# Amendment and Supplement to brown\_01\_0312

**IEEE P802.3bj**

March 2012, Hawaii

- Amendment to brown\_01\_0312 “100G backplane PAM4 PHY encoding (revised)”
  - Corrections to slides 4 and 26.
- Supplement brown\_01\_0312 with electrical test methodology and parameters based on
  - moore\_02\_0312
  - bliss\_01a\_0911

Differential output return loss (min)

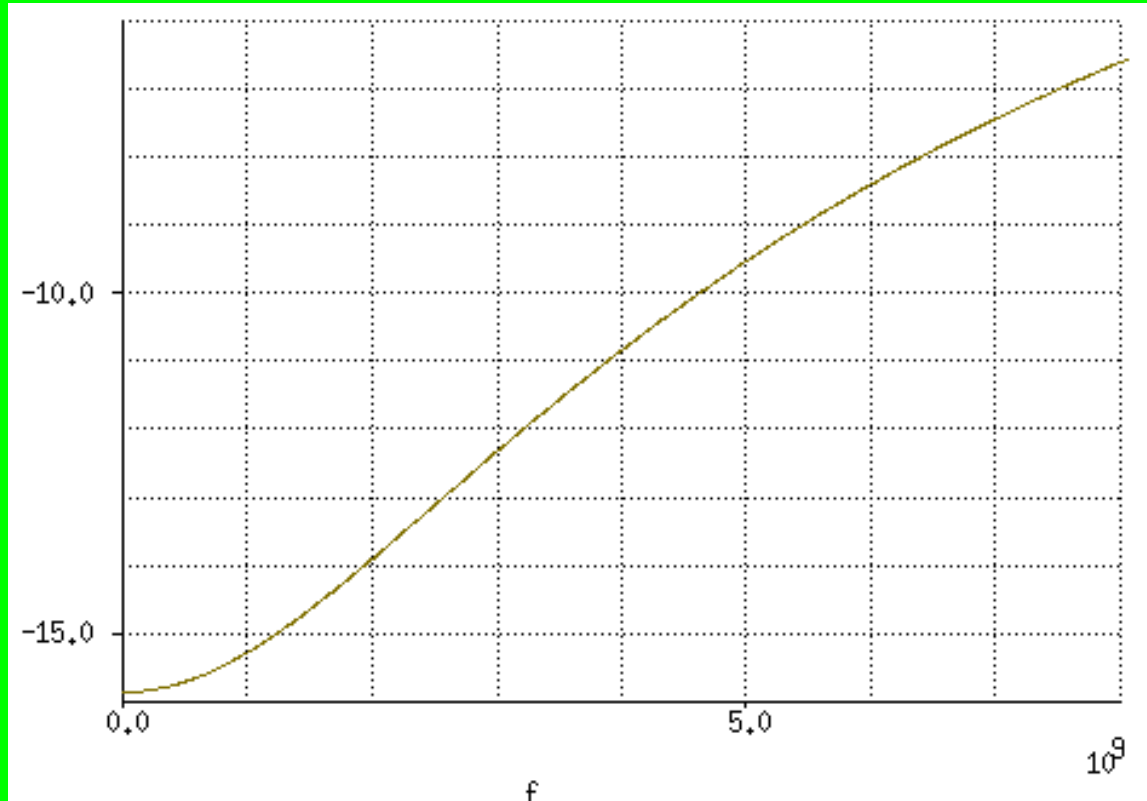
3 Change equation 85.1 (return loss) as shown in slides 13 and 14 for PAM4.

Note: equation 85.1 will be used in finding re-reflection noise so we will have some rational basis for choice.

$$\text{Return\_loss}(f) = 10 \cdot \log_{10} \left( \frac{\Gamma_{01}^2 + (f/f_1)^2}{1 + (f/f_1)^2} \right) \quad f < 8\text{GHz}$$

$f$  in Hz

$$f_1 = 1.6 \cdot 10^{10}$$

$$\Gamma_{01} = 0.161$$
